# UNITED STATES PATENT AND TRADEMARK OFFICE

10/719,786

Edward Paul Carlin

<b>Office Action Summary</b>	<b>Application No.</b>		<b>Applicant(s)</b>	
	10/719,786		CARLIN, EDWARD PAUL	
	<b>Examiner</b>		<b>Art Unit</b>	
	Michael G. Bogart		3761

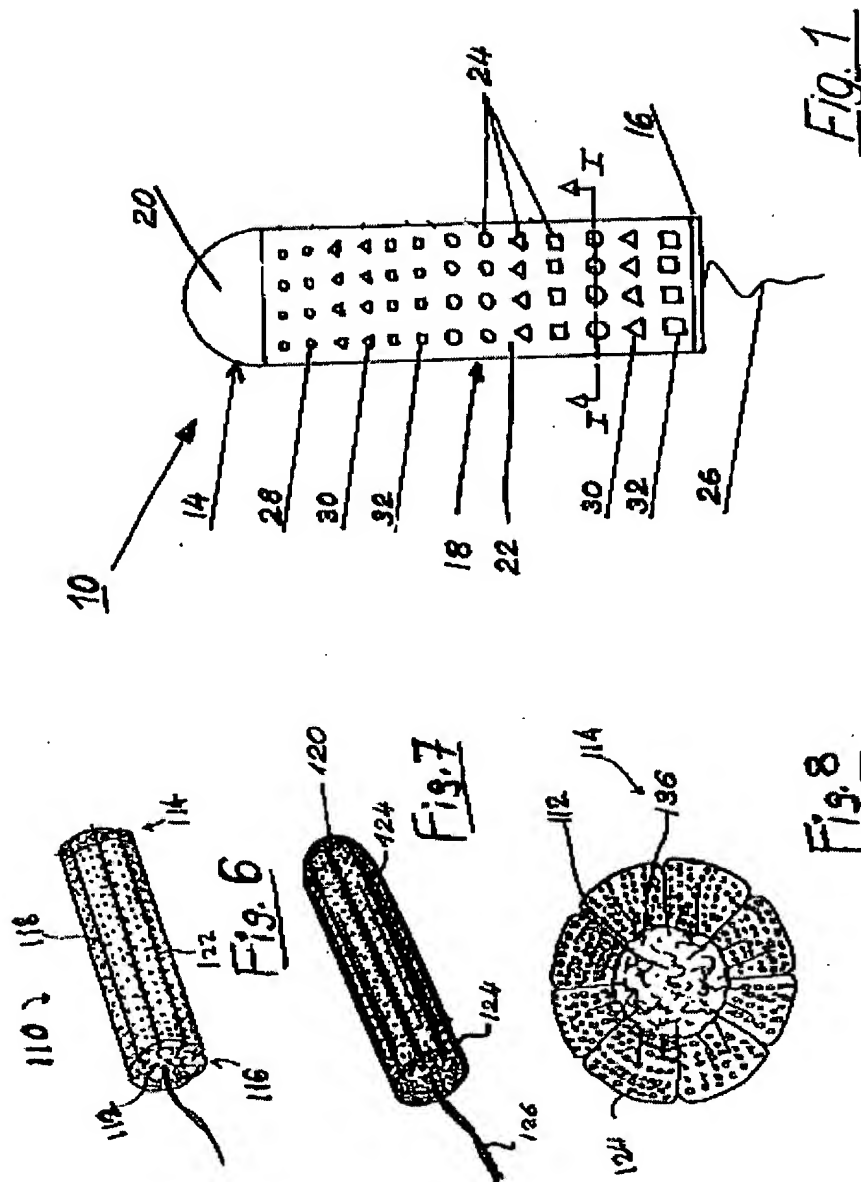
Regarding claim 13, Schoelling teaches a tampon (10) for feminine hygiene comprising an insertion end (14), a withdrawal end (16), a length, a longitudinal axis, a radial axis, and an outer surface (22);

wherein a measured portion of said outer surface of said insertion end (14) comprises a first surface area and a measured portion of said outer surface of said withdrawal end (16) comprises a second surface area, said first surface area being different than said second surface area, wherein at least a portion of said first surface area comprises grooves, wherein said grooves are selected from the group consisting of longitudinal grooves, horizontal grooves and mixtures thereof (see figures 1 and 6-8, below), wherein at least a portion of the first surface area further comprises surface aberrations (28).

Schoelling is silent as to the specific length of the grooves and does not teach protuberances.

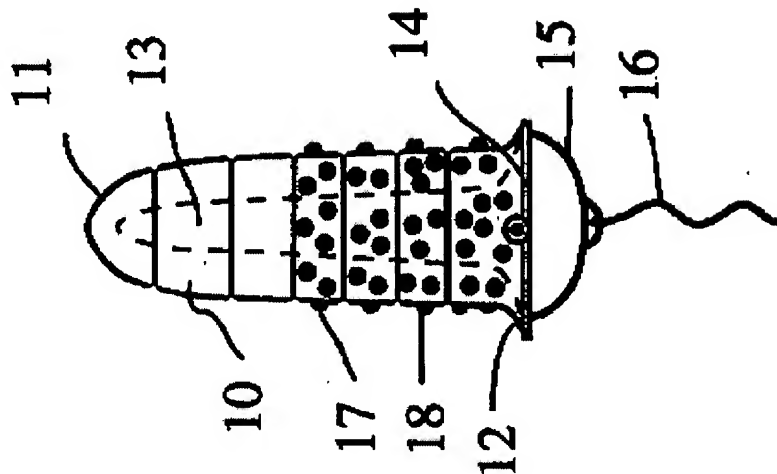
Policappelli teaches a tampon having protuberances (17, 18) on its surface (figure 1, below). These protuberances improve tampon comfort in use (§ 0021).

At the time of the invention, it would have been obvious to one of ordinary skill in the art to add the protuberances of Policappelli to the tampon of Schoelling in order to provide for increased comfort for a user of the device.

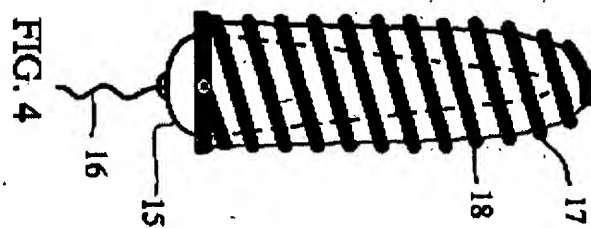
Regarding claims 5 and 6, Schoelling teaches a straight line or checkerboard pattern of evenly spaced surface aberrations (28)(figure 1).

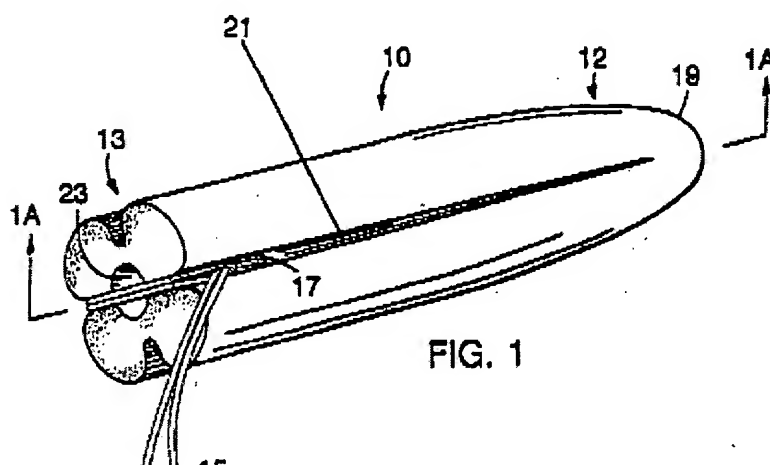
Regarding claims 9-11, Schoelling teaches grooves arranged in an evenly spaced straight line pattern (figures 6-8).

Regarding claim 14, Schoelling teaches longitudinal grooves (figures 6-8).

Regarding claim 18, Schoelling teaches an essentially uniform density (figure 8).
